DRAINAGE CERTIFICATION

TITLE: SUNDORO SOUTH SUBDIVISION UNITS 1 & 3
GRADING AND DRAINAGE PLAN
ENGINEER'S CERTIFICATION

TITLE: ENGINEER'S CERTIFICATION
SUNDORO SOUTH SUBDIVISION UNIT 2
GRADING AND DRAINAGE PLAN

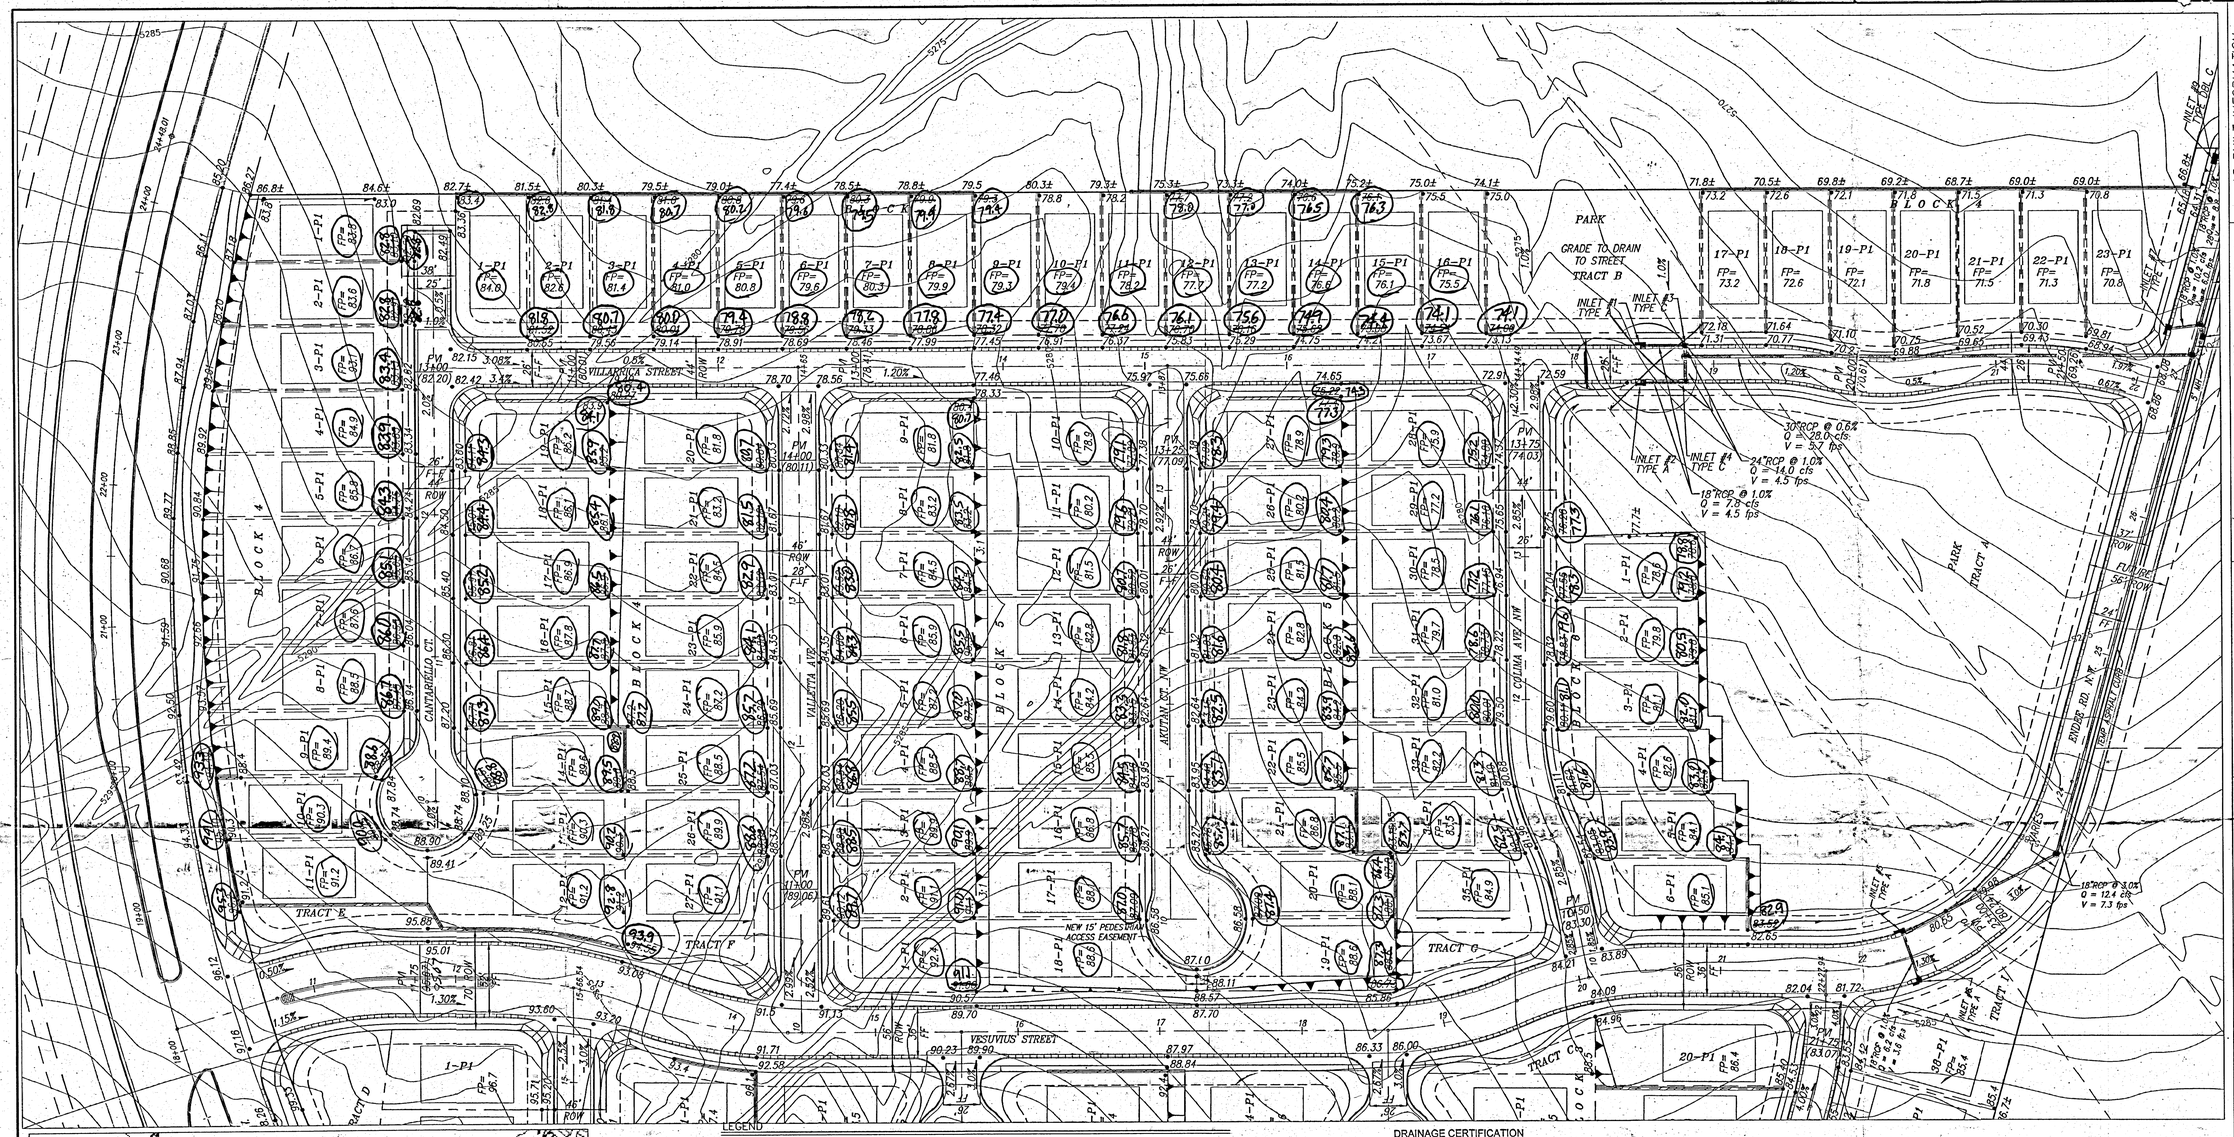
1. Dirt grades on the south side of Ladera and east side of Vesuvius were low between the meandering sidewalk and wall on the edge of the right-of-way. Fill is needed to keep right-of-way drainage in right-of-way and off of adjacent private lots. (Westland Development will finish the grading there with the landscaping.

2. Rear corners of Lots 2 & 3, Block 2 are 1' to 3' lower than planned and wont' drain to the street. (The retaining wall will be raised by Westland Development's wall builder.)

3. The southeast rear corner of Lot 36, Block 1 is 0.8' low but it will still drain. (Side yard may be steep if Home Builder does not add a course to the wall.)

4. The northeast rear corner of Lot 5, Block 3 is 1.8' low. (The Builder will re-grade so rear yard drains to front, some fill may be needed.)
5. The wall termination on the northeast corner at Lot 1, Block 3 is too abrupt. (The Builder should taper the dirt behind the wall.)

1. The 2:1 slopes at the west end of the two cul-de-sacs on Vesuvius was flattened to 3:1 or flatter with the addition of retaining walls at the top of these slopes, so gravel much is no longer needed there.
2. The slope in the rear yards of Lots 17 through 25, Block 2 is not exactly as planned, but it still drains as planned.
3. The pond was constructed in substantial compliance with the plans, but is now being moved to the East side of Unit 6 in accordance with that separate plan.

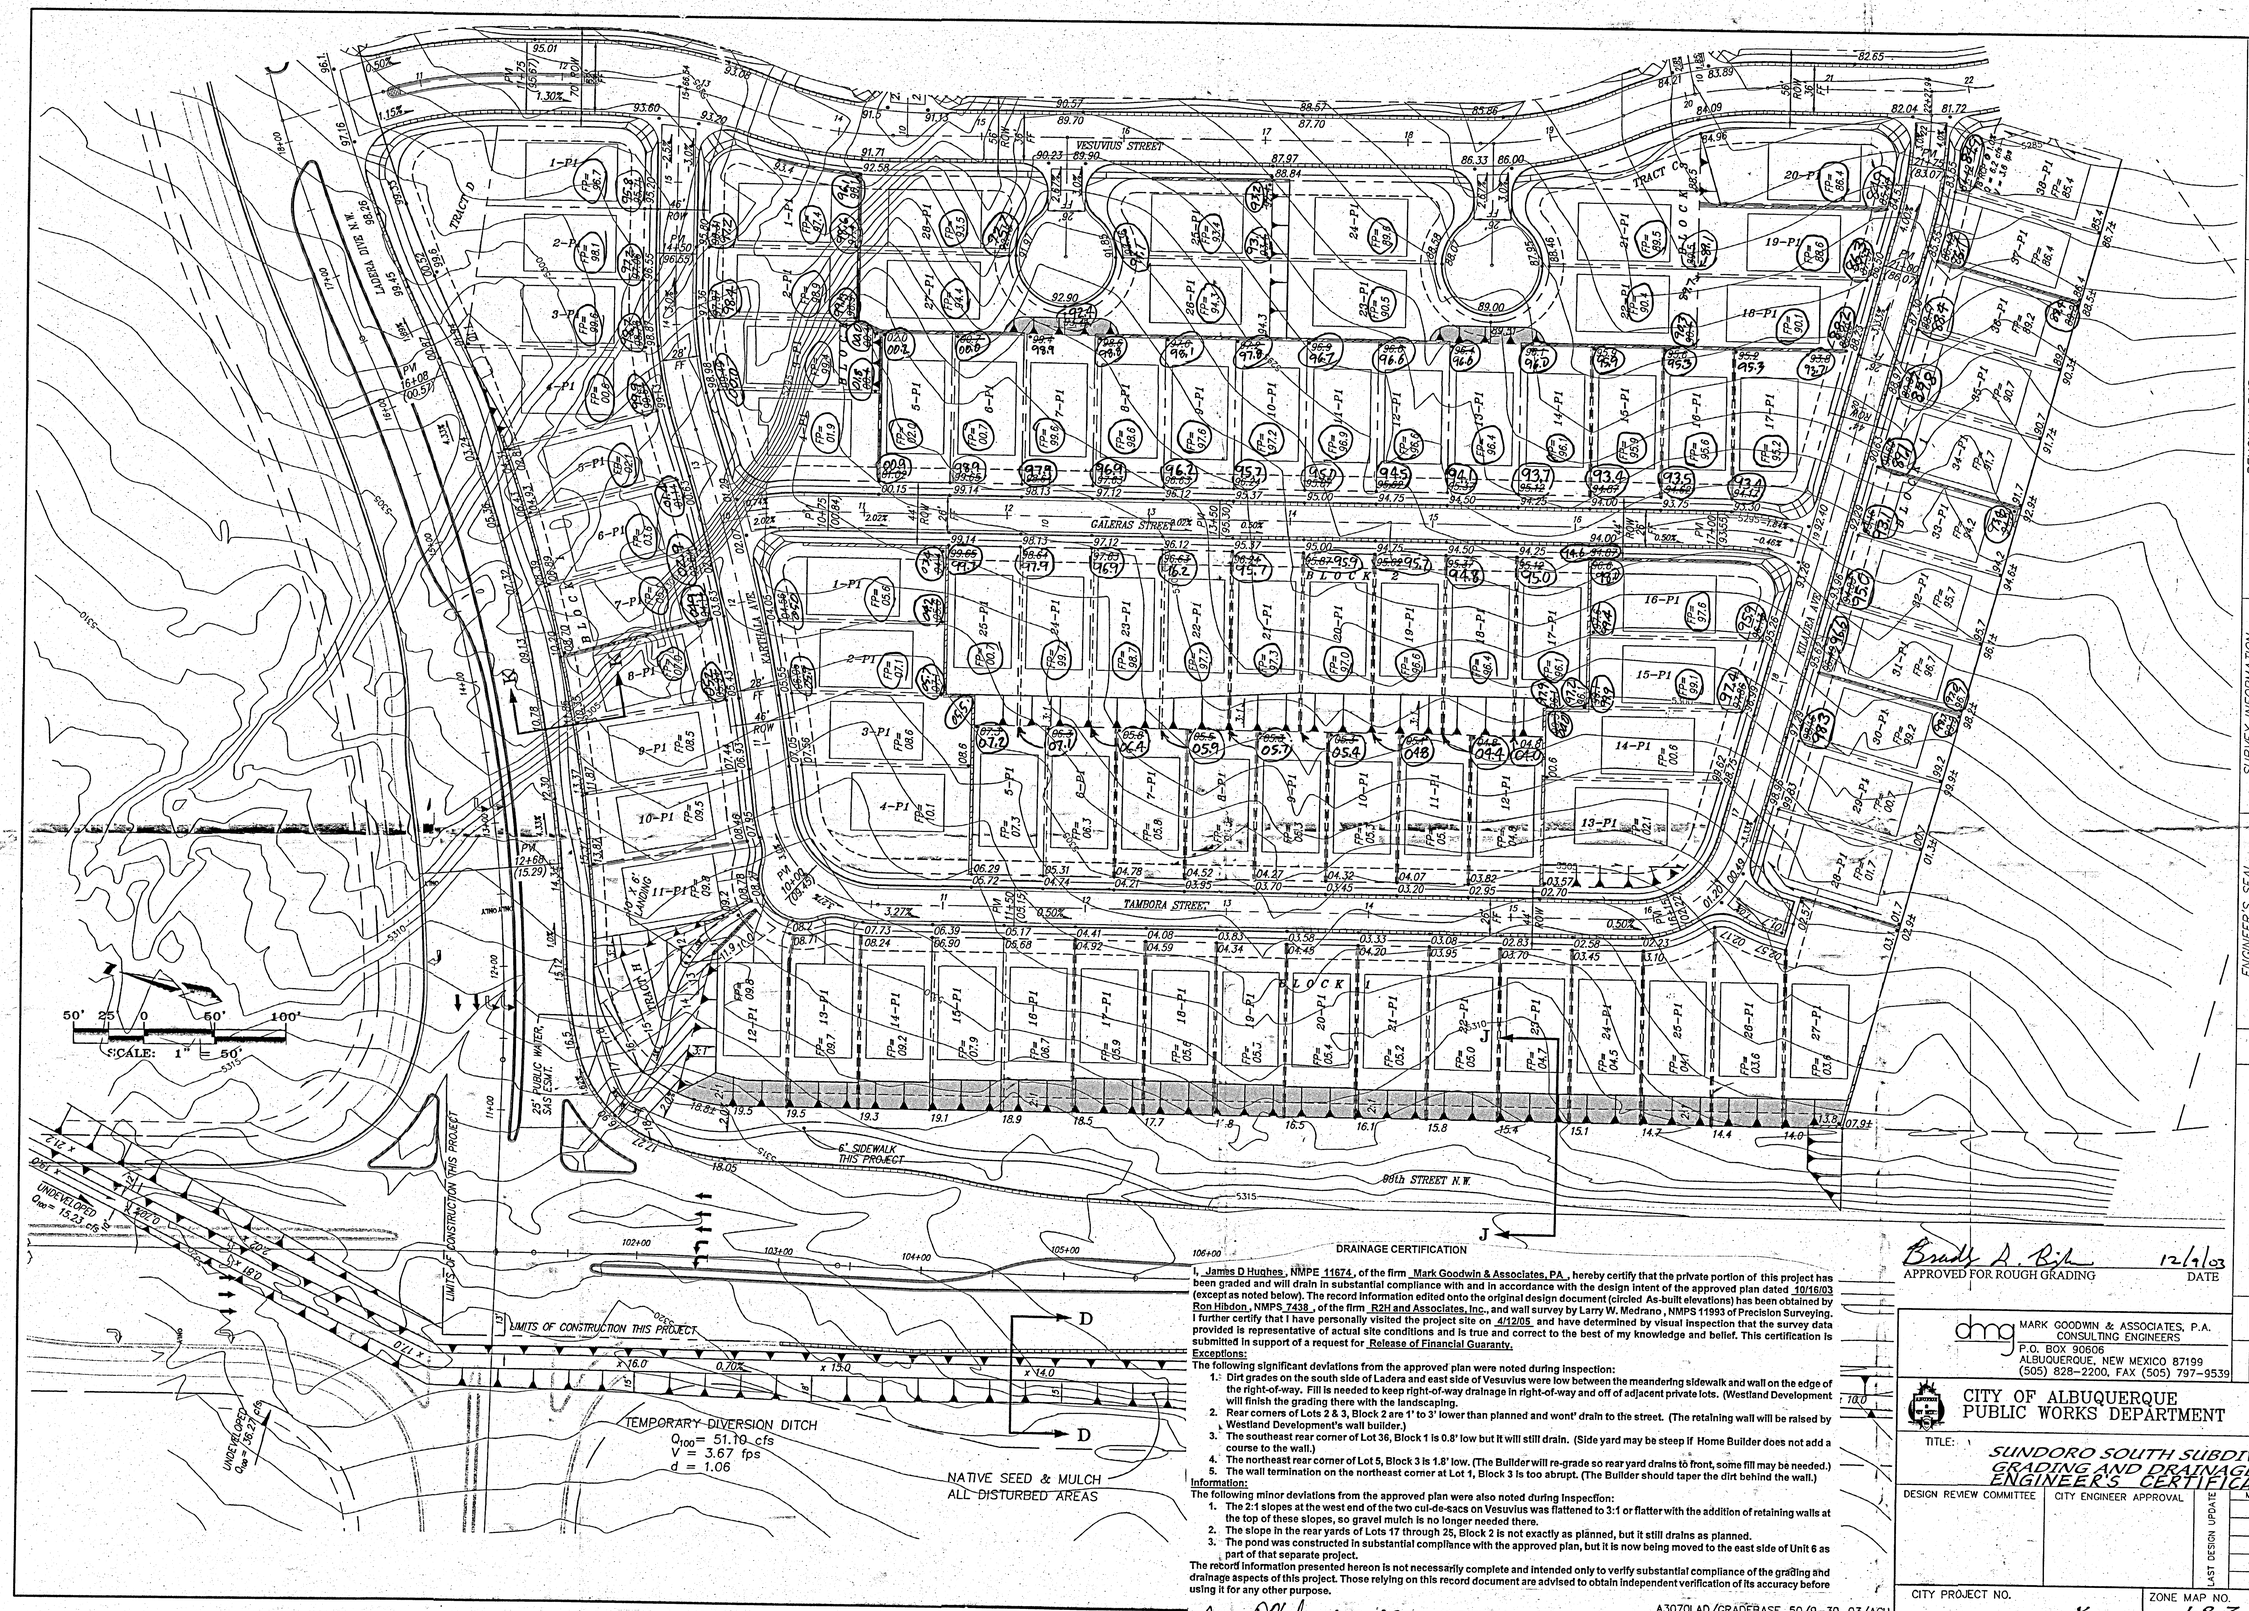
Exceptions:
The following significant deviations from the approved plan were noted during inspection:
1. Dirt grades on the south side of Ladera and east side of Vesuvius were low between the meandering sidewalk and wall on the edge of the right-of-way. Fill is needed to keep right-of-way drainage in right-of-way and off of adjacent private lots. (Westland Development will finish the grading there with the landscaping.

2. Rear corners of Lots 2 & 3, Block 2 are 1' to 3' lower than planned and wont' drain to the street. (The retaining wall will be raised by Westland Development's wall builder.)

3. The southeast rear corner of Lot 36, Block 1 is 0.8' low but it will still drain. (Side yard may be steep if Home Builder does not add a course to the wall.)

4. The northeast rear corner of Lot 5, Block 3 is 1.8' low. (The Builder will re-grade so rear yard drains to front, some fill may be needed.)
5. The wall termination on the northeast corner at Lot 1, Block 3 is too abrupt. (The Builder should taper the dirt behind the wall.)
Information:
The following minor deviations from the approved plan were also noted during inspection:

1. The 2:1 slopes at the west end of the two cul-de-sacs on Vesuvius was flattened to 3:1 or flatter with the addition of retaining walls at the top of these slopes, so gravel mulch is no longer needed there.

2. The slope in the rear yards of Lots 17 through 25, Block 2 is not exactly as planned, but it still drains as planned.
3. The pond was constructed in substantial compliance with the approved plan, but it is now being moved to the east side of Unit 6 as part of that separate project.
The record information presented hereon is not necessarily complete and intended only to verify substantial compliance of the grading and drainage aspects of this project. Those relying on this record document are advised to obtain independent verification of its accuracy before using it for any other purpose.
James D Hughes 4-19-05
James D. Hughes NMPE 11674
A3070LAD/GRADEBASE_50/9-30-03/ACH
Brady A. Bich 12/9/03
APPROVED FOR ROUGH GRADING DATE
dmg MARK GOODWIN & ASSOCIATES, P.A.
CONSULTING ENGINEERS
P.O. BOX 90606
ALBUQUERQUE, NEW MEXICO 87199

DRAINAGE CERTIFICATION

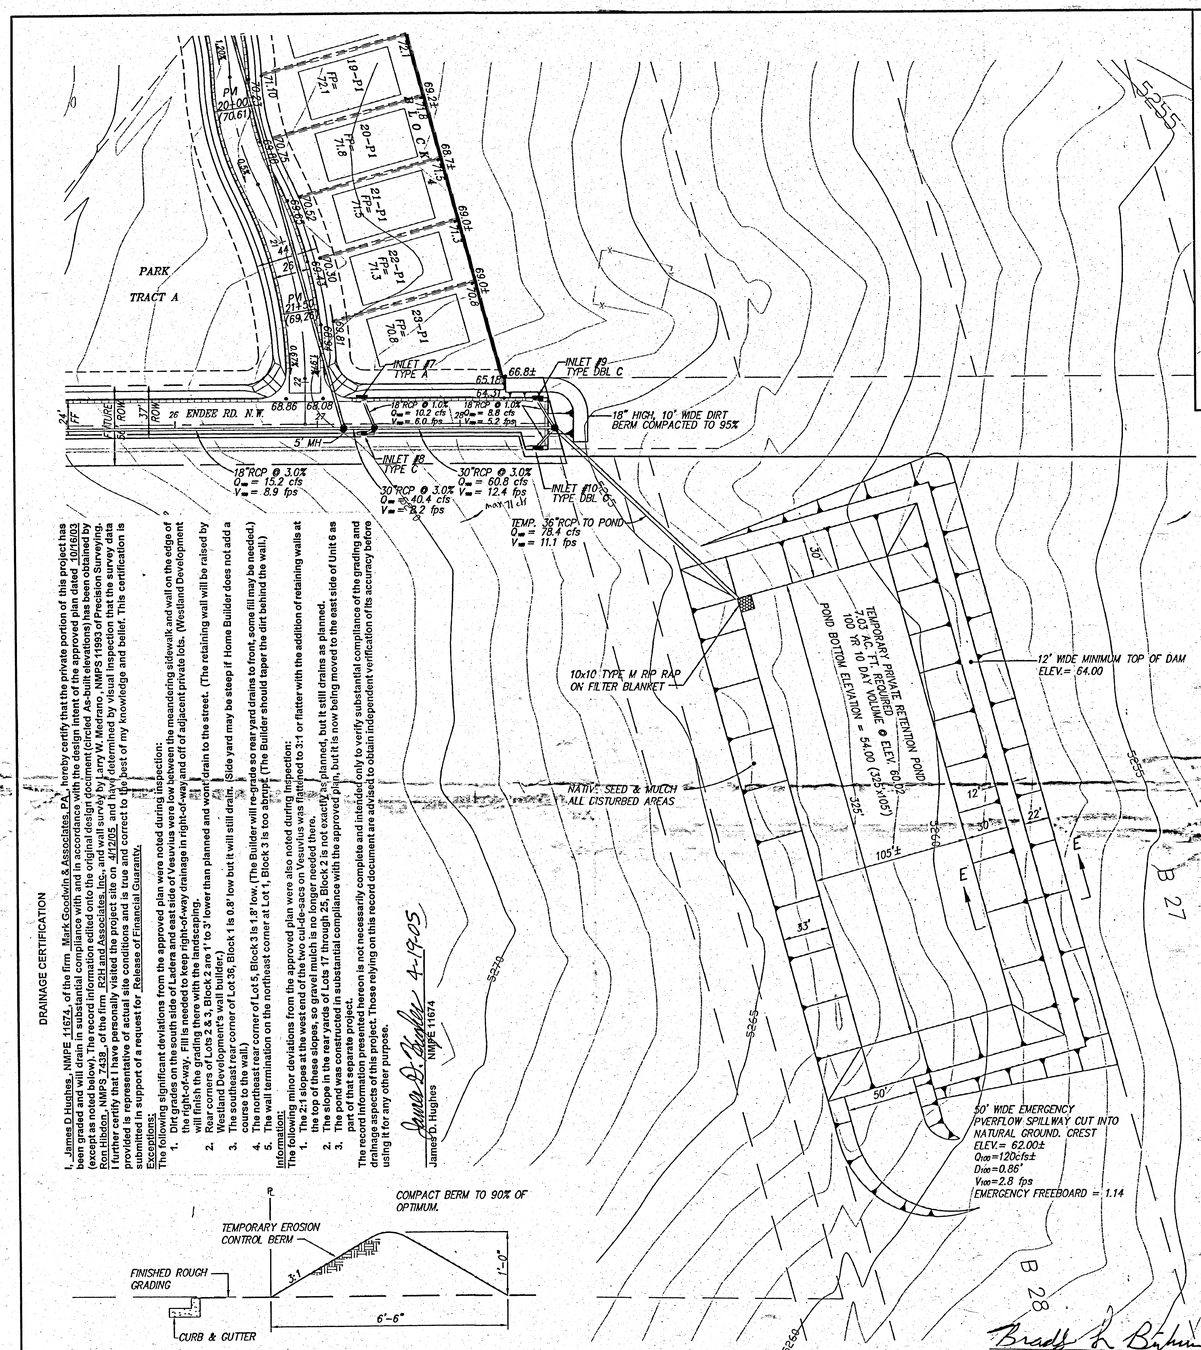
1. Dirt piled along the west and east side of Vesuvius were low between the meandering sidewalk and wall on the edge of the roadway. Fill is needed to keep right-of-way drainage in right-of-way and off of adjacent private lots. (Westland Development will finish the grading there with the landscaping.
2. Rear corners of Lots 2 & 3, Block 2 are 1' to 3' lower than planned and won't drain to the street. (The retaining wall will be raised by Westland Development's wall builder.)
3. The southeast rear corner of Lot 35, Block 1 is 0.8' low but it will still drain as planned.
4. The southwest rear corner of Lot 5, Block 3 is 1.8' low. (The Builder will re-grade so rear yard drains to front, some fill may be needed.)
5. The northwest rear corner of Lot 1, Block 3 is too abrupt. (The Builder should taper the dirt behind the wall.)

1. The 2:1 slopes at the west end of the two cul-de-sacs on Vesuvius was flattened to 3:1 or flatter with the addition of retaining walls at the top of these slopes, so grading is no longer as planned, but it still drains as planned.
2. The 2:1 slope on the east side of Lots 17 through 25, Block 2 is not exactly as planned, but it is now being moved to the east side of Unit 6 as part of that separate project.
3. The pond was constructed in substantial compliance with the approved plan, but it is not exactly as planned.
